doc.: IEEE 802.11-99/074

## Constellation Bit Encodings for IEEE 802.11 OFDM System

- Bob Ward in Cooperation with Symbol Technologies, Inc.

## BPSK, QPSK and 16 QAM Constellation Encoding

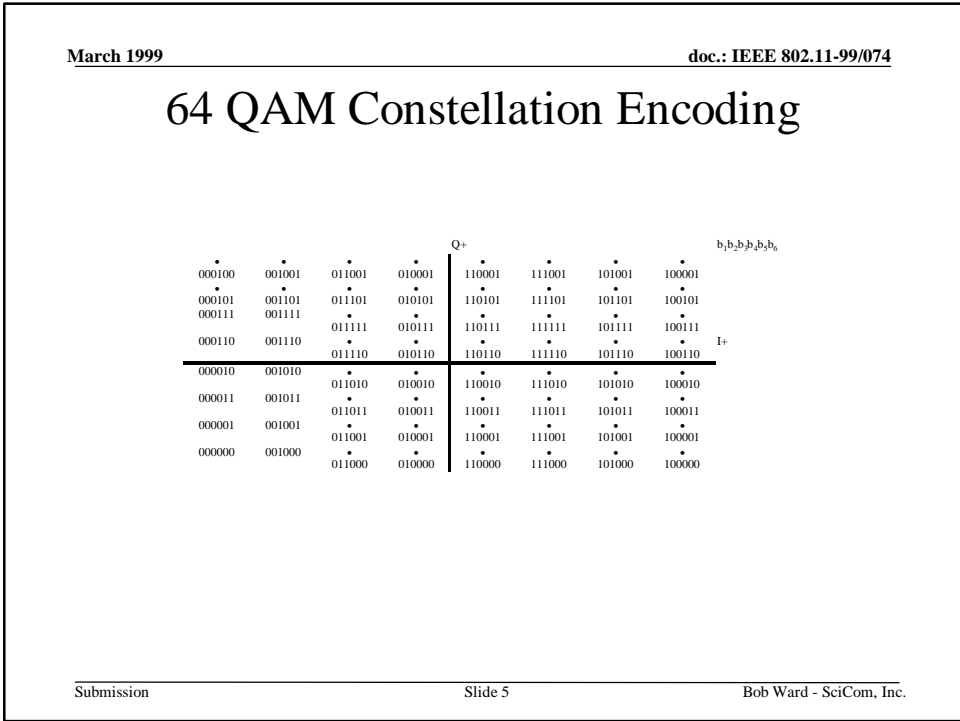
- March 1999 doc.: IEEE 802.11-99/074
- ## Recommendation
- Move to:
    - Clarify Bit Encoding with constellation encoding diagrams provided in this recommendation
    - Include in 17.3.5.7, the reference to the necessary power normalization factors (as was in earlier drafts) included in a separate paragraph
  - Benefits
    - Follows IEEE Standard conventions for bit encoding descriptions
    - Clarity
    - Easy storage of bit encoding tables (since @ integer locations)
    - Separates bit encoding and power normalization requirements
- Submission Slide 6 Bob Ward - SciCom, Inc.

- For constellation description
  - In each constellation, symbols are located at integer points, within the following sets
    - BPSK,  $\{I_i, Q_i\} = \{(1,1) \text{ and } (-1,-1)\}$
    - QPSK,  $\{I_i, Q_i\} = \{\pm 1, \pm 1\}$
    - 16 QAM,  $\{I_i, Q_i\} = \{\pm 1, \pm 3\}$
    - 64 QAM,  $\{I_i, Q_i\} = \{\pm 1, \pm 3, \pm 5, \pm 7\}$
- Transmitted I and Q values are normalized by power scaling to achieve unity average power
  - reference the clause on normalization
